**18/0368/OUT | Outline application for the demolition of existing structures, site remediation and redevelopment to provide Classes A1 (retail), A3 (Cafes and Restaurants), associated access, internal circulation, service yards, parking, landscaping, public realm works, infrastructure and dedication of land for improvements to Honiton Road (all matters reserved except access). | WPD Depot Moor Lane Exeter Devon EX2 7JF**

3rd April 2018

Exeter Cycling Campaign **object** to the proposed development for the following reasons:

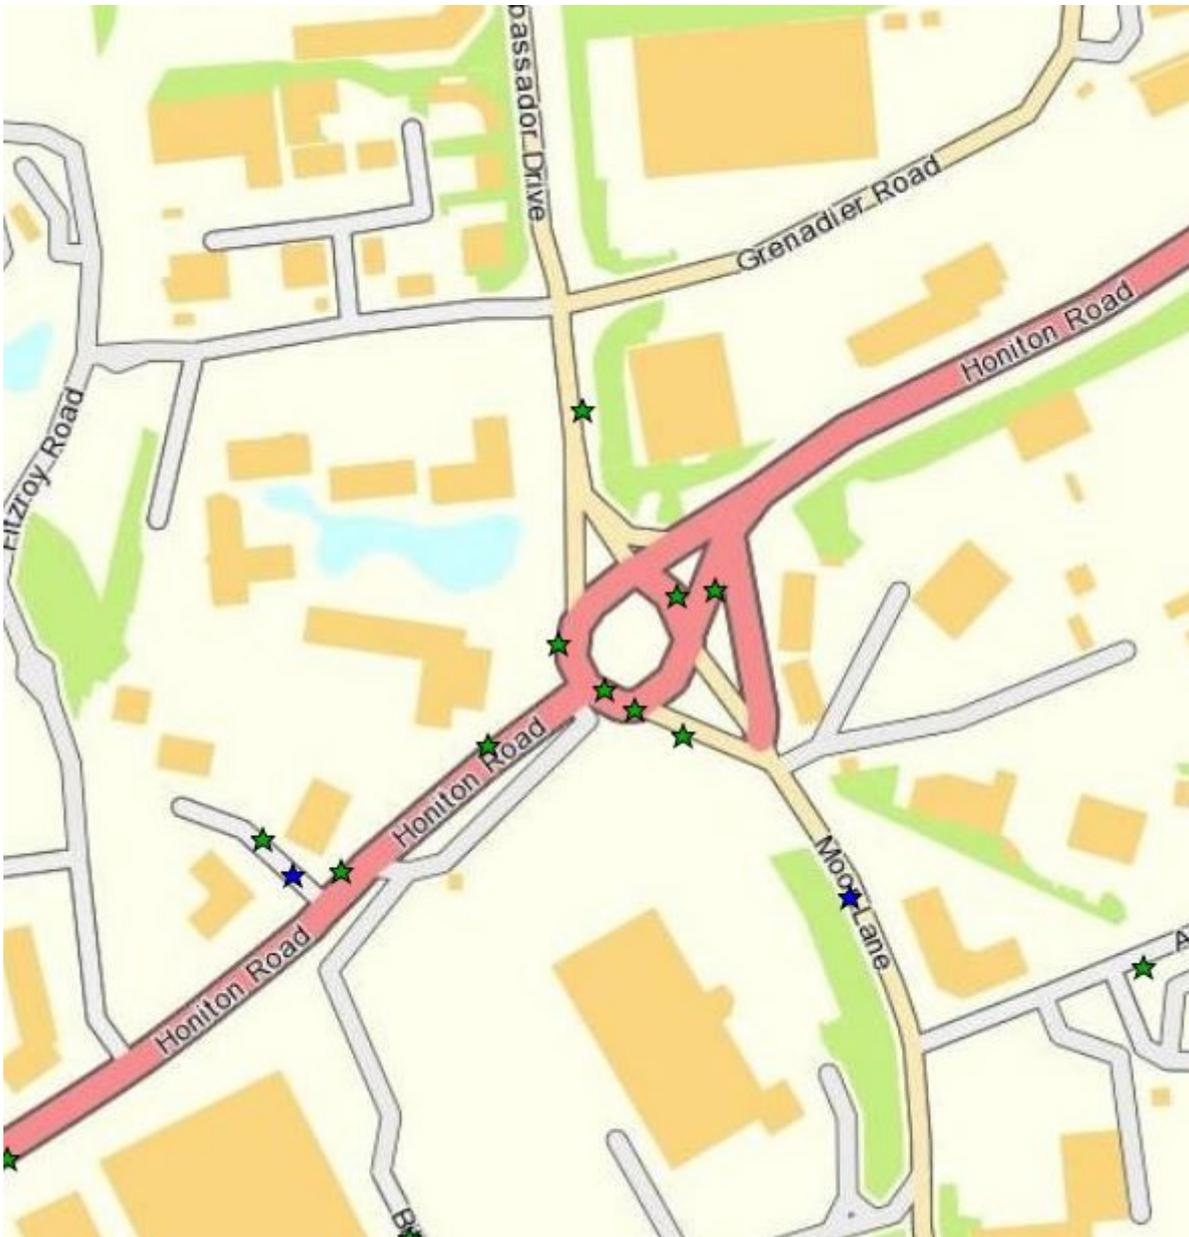
The Devon Collision Map, providing data up to December 2016, shows multiple collisions on and in the vicinity of Honiton Road/Moor Lane roundabout (Figure 1). This therefore makes the roundabout a collision cluster spot and demonstrates that it is not safe. By definition, the roundabout and approaches will be particularly unsafe for vulnerable road users and unattractive to cycle on the road. The lack of quality, connected, segregated cycle routes in the area means that less confident cyclists or parents cycling with children are not likely to cycle to the proposed development. This will further increase car usage, while putting vulnerable road users on Honiton Road, Moor Lane and the roundabout at greater risk.

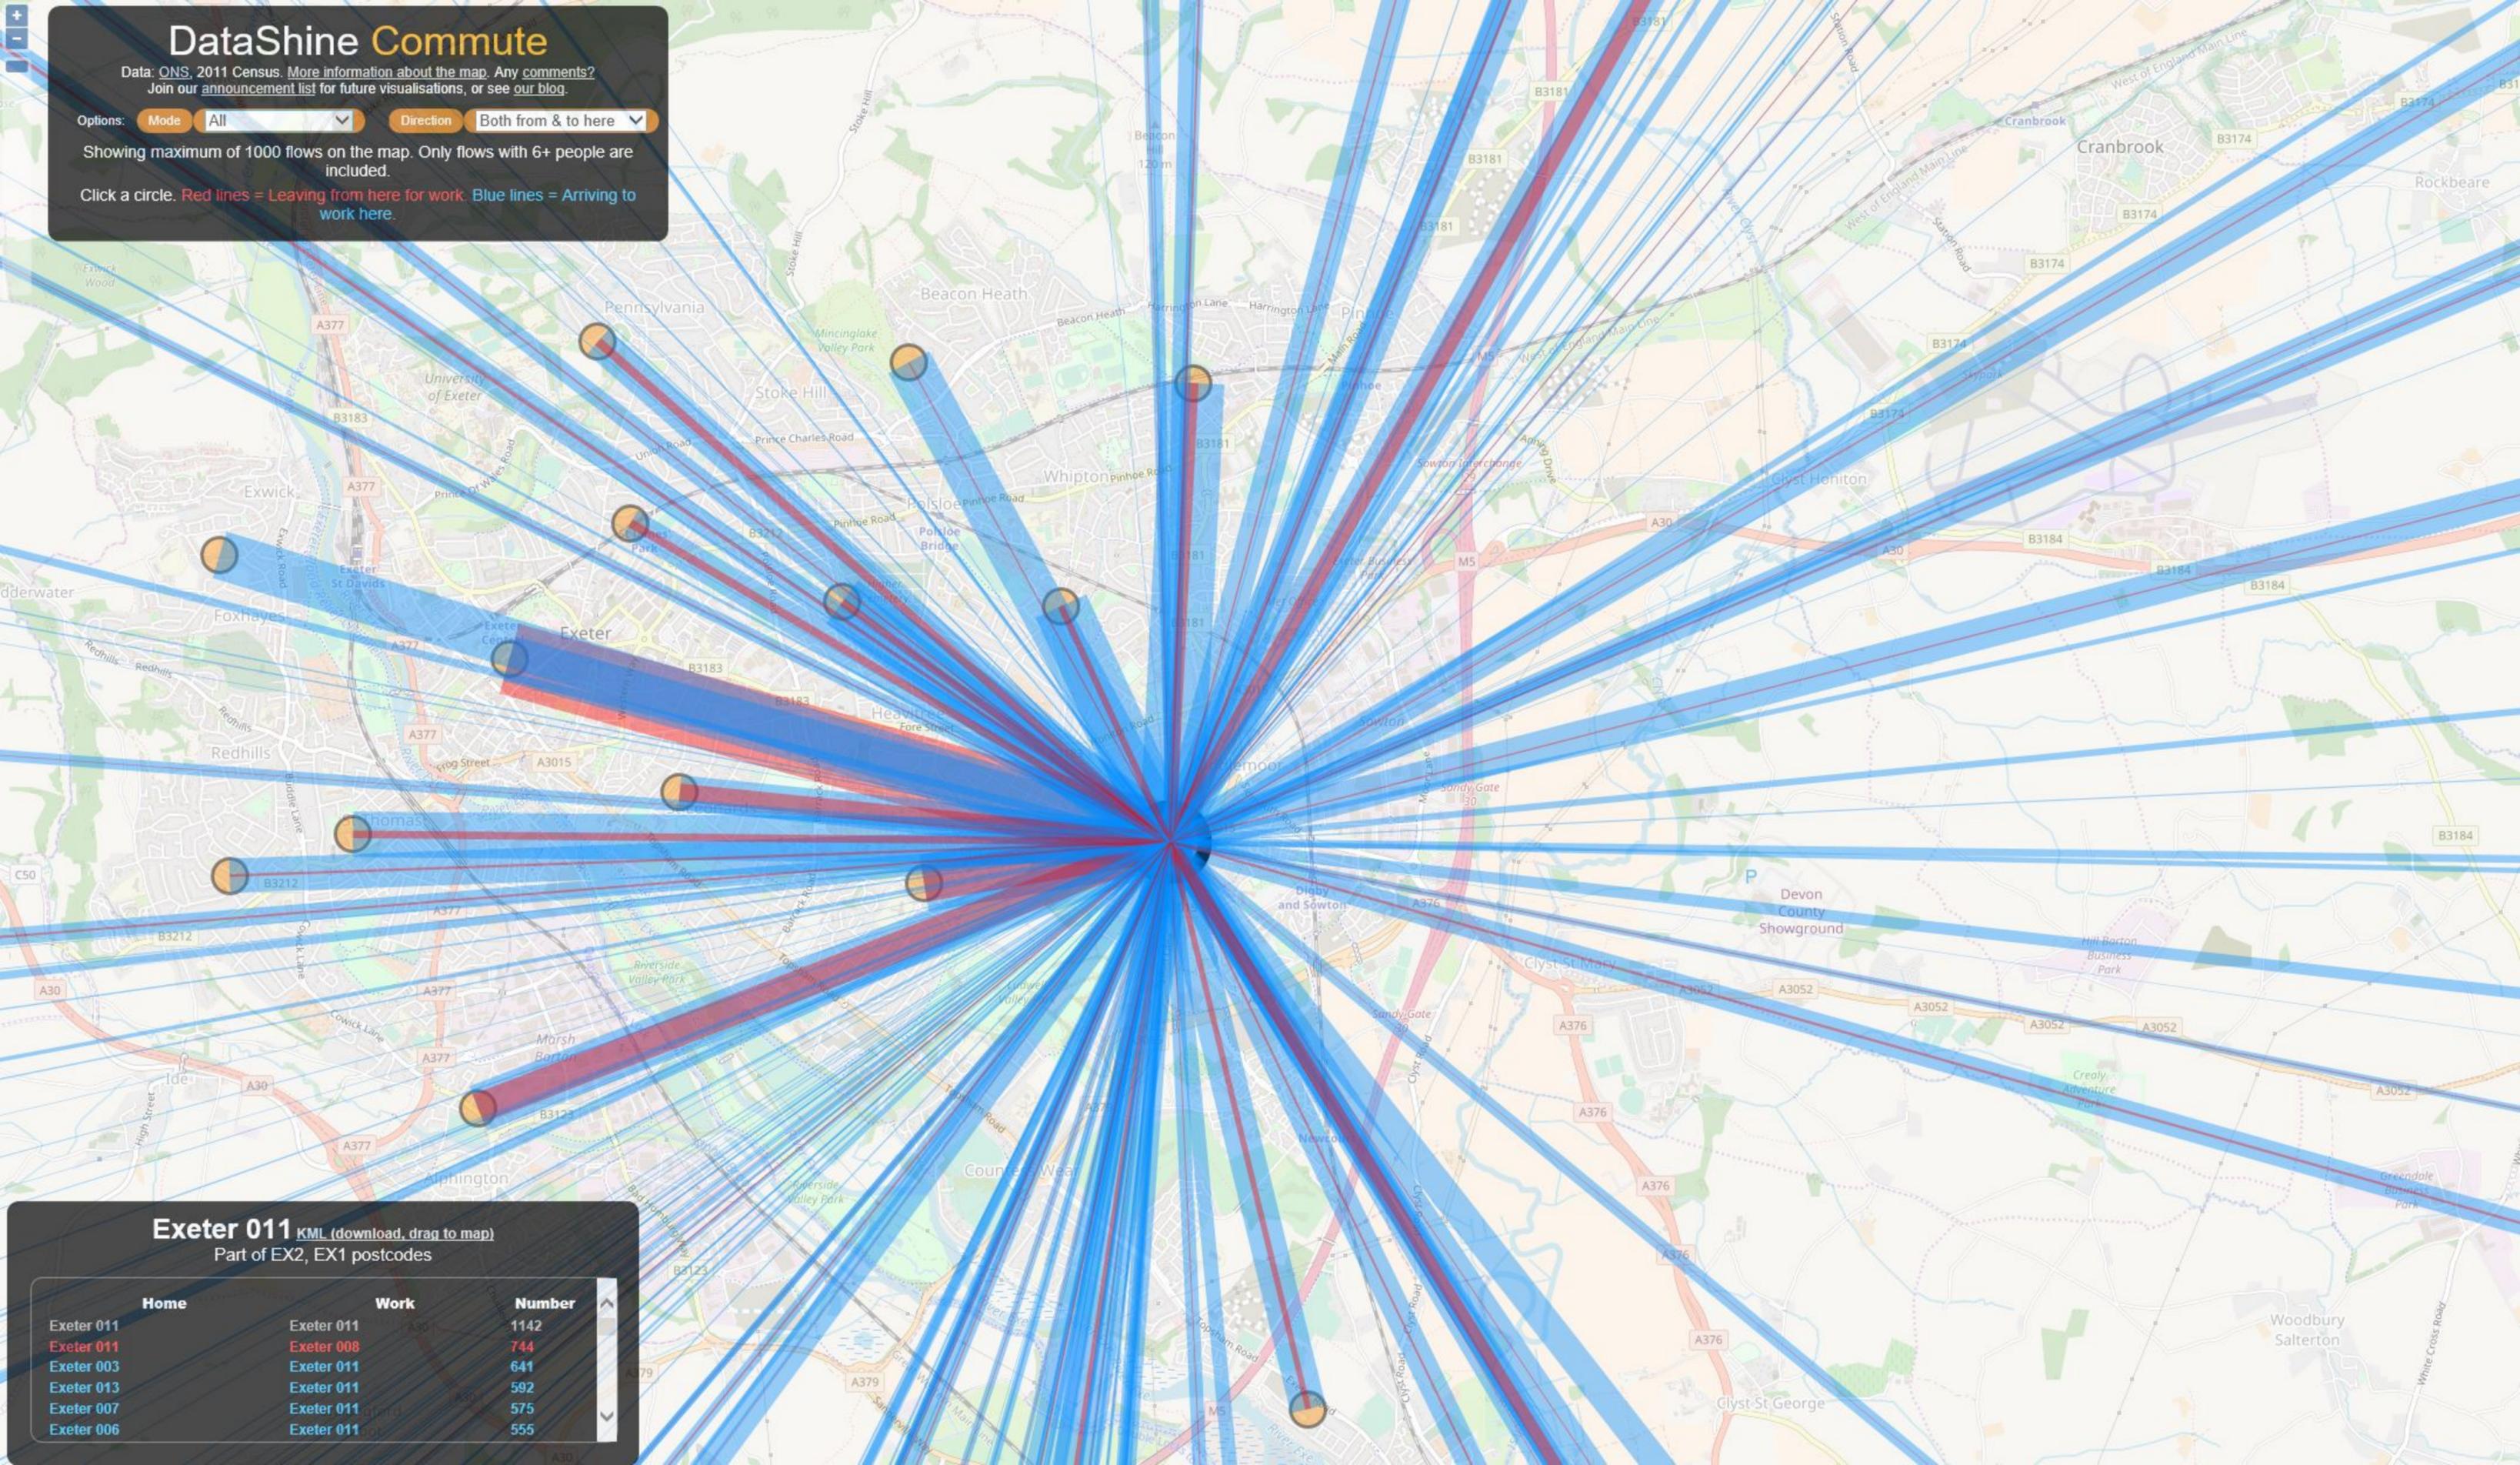
The proposed development will generate a significant amount of traffic, containing as it does a large element of comparison retail and being centred around a 336 space car park. This will inevitably attract residents from elsewhere in the city and outside.
